PLANNING COMMISSION MEETING AGENDA

AGP-1 Industrial Building – 22860 NE Townsend Way
Type III Quasi-Judicial Procedure

**PLANNING COMMISSION STAFF REPORT
TYPE III SITE DESIGN REVIEW
FINDINGS AND STAFF RECOMMENDATION**

Application Number: 2020-20-DR

L1.0
 JOB NUMBER: A20014.10

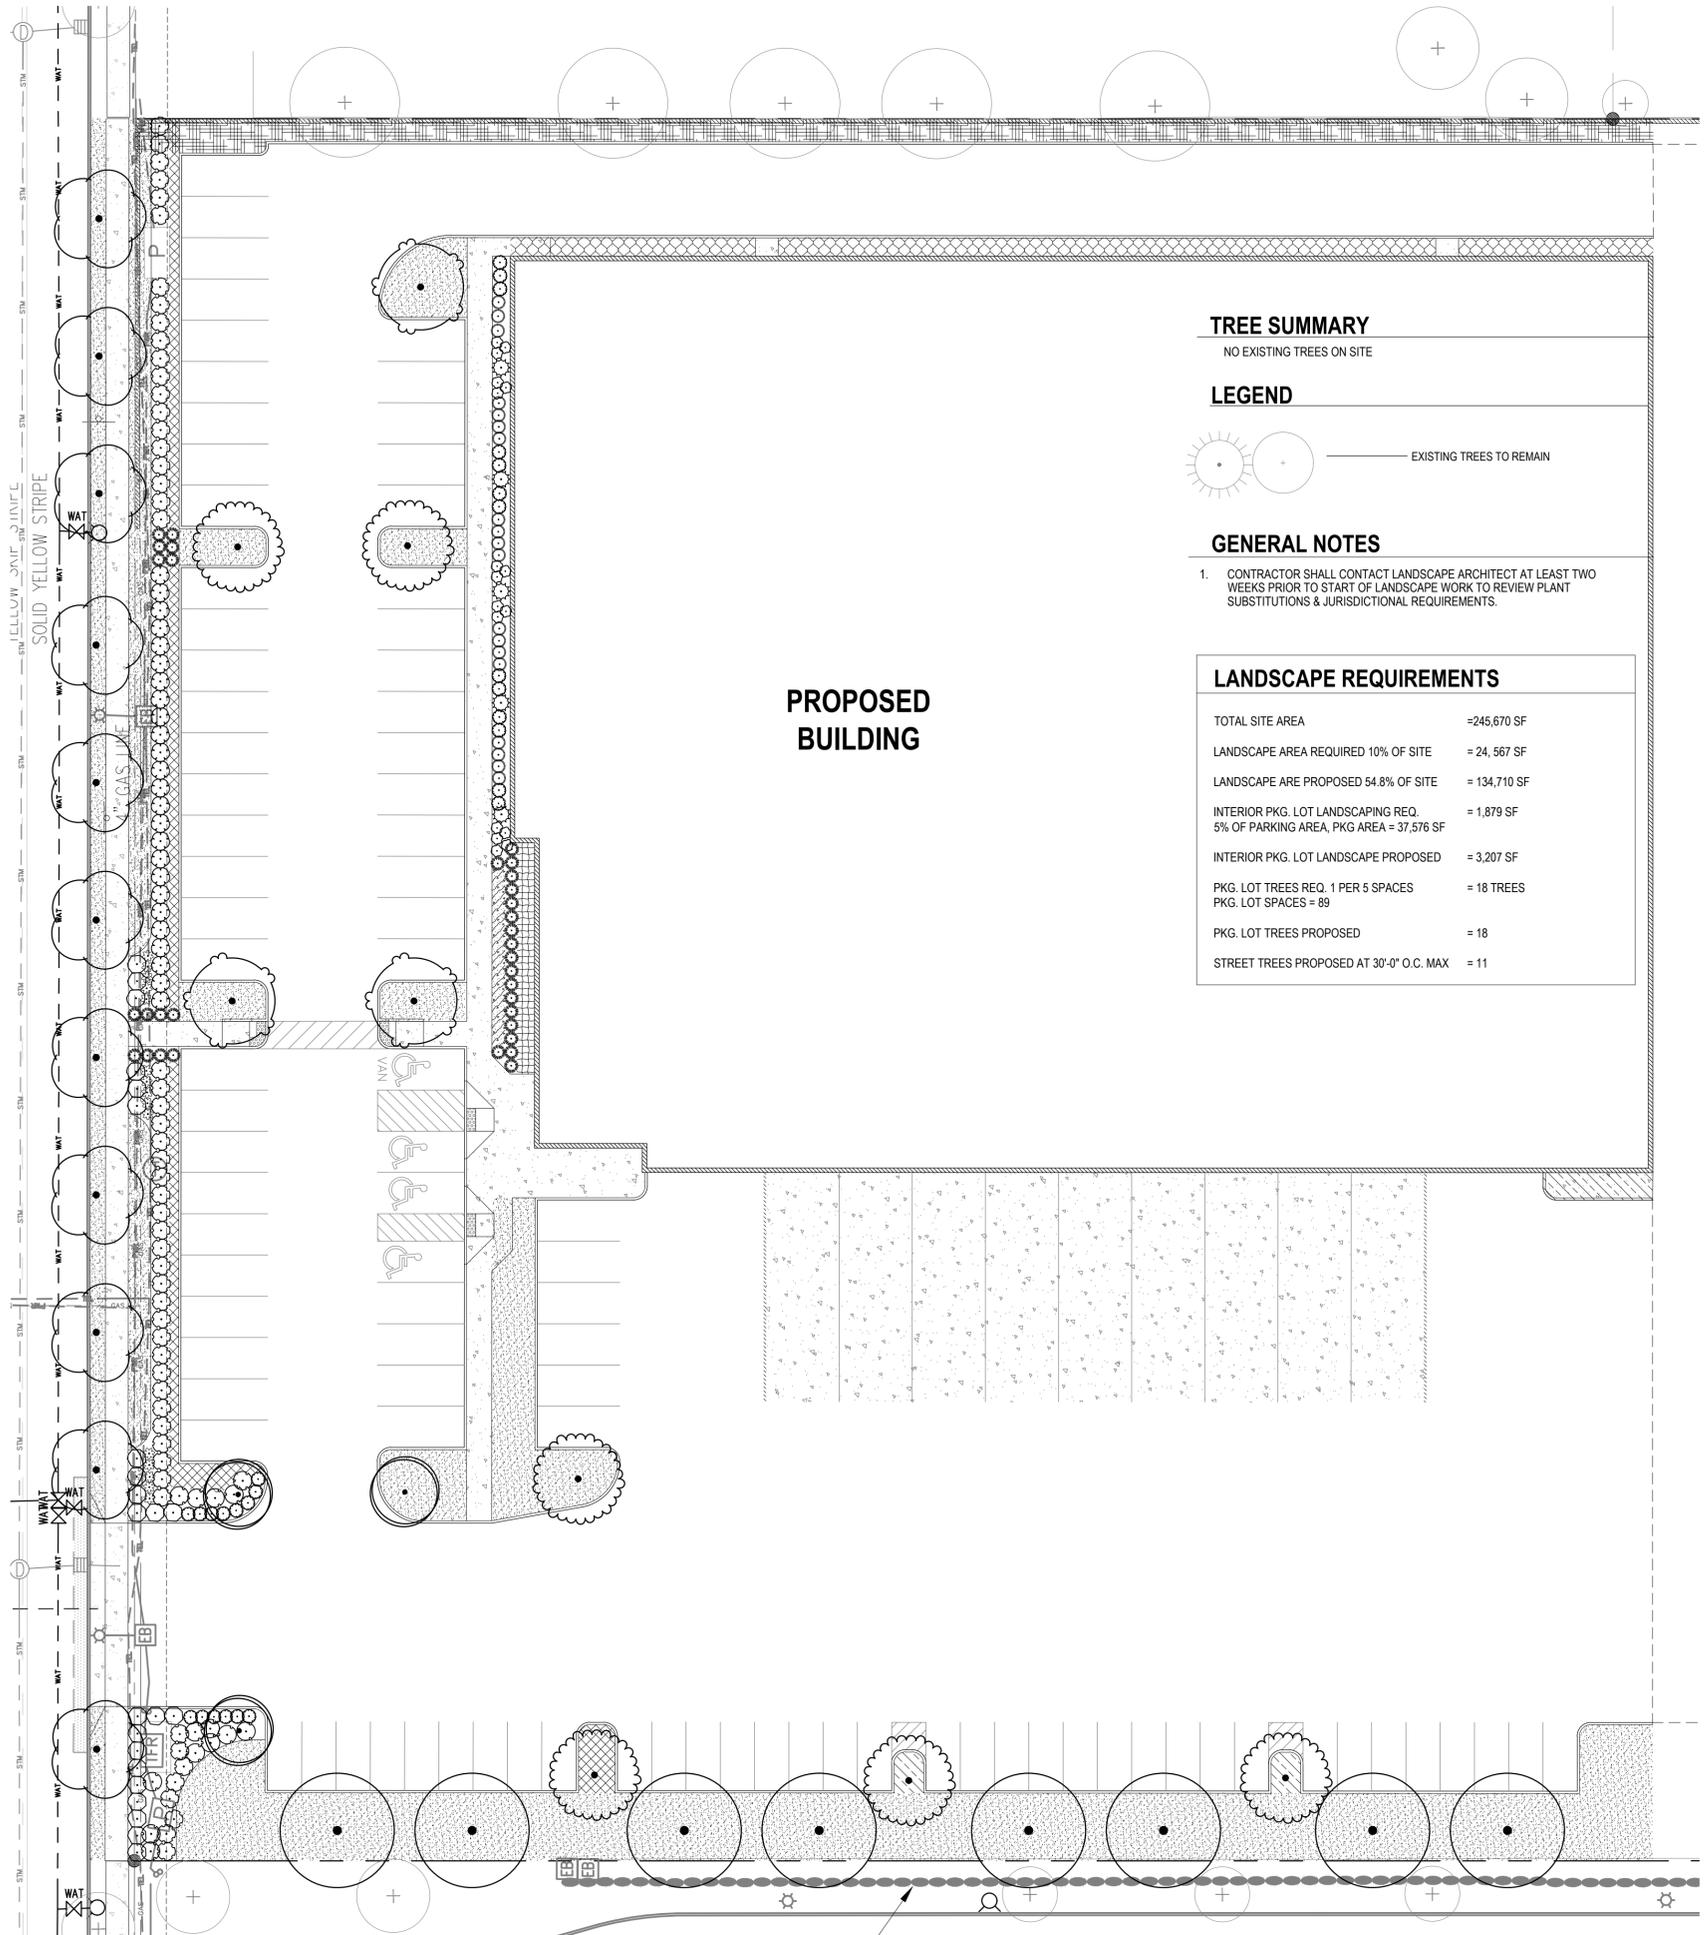
FINDINGS: A landscape plan has been submitted as part of the design review application (Exhibit B – Sheet L1.10). This standard is met.

FINDINGS: The total site area is 245,670 SF and the proposed landscaped area is 24,567 SF, equal to 10% of the site. The applicant’s plans are unclear regarding 10% landscape development during phase one. This standard is not met.

FINDINGS: The landscape plan, site plan and narrative propose 7 types of groundcovers.

FINDINGS: According to the landscape plans, all of the proposed trees will be 1.5 inch caliper at the time of planting (Exhibit B – Sheet L1.10). This standard is met.

Condition of Approval: Prior to issuance of building permits, provide a revised landscape plan that demonstrates compliance with the 10% landscaping requirement as planned for completion during phase one.

Condition of Approval: Prior to the issuance of building permits the landscape plan shall be revised or clarified to show that no more than five percent of the landscape area is nonplant materials.
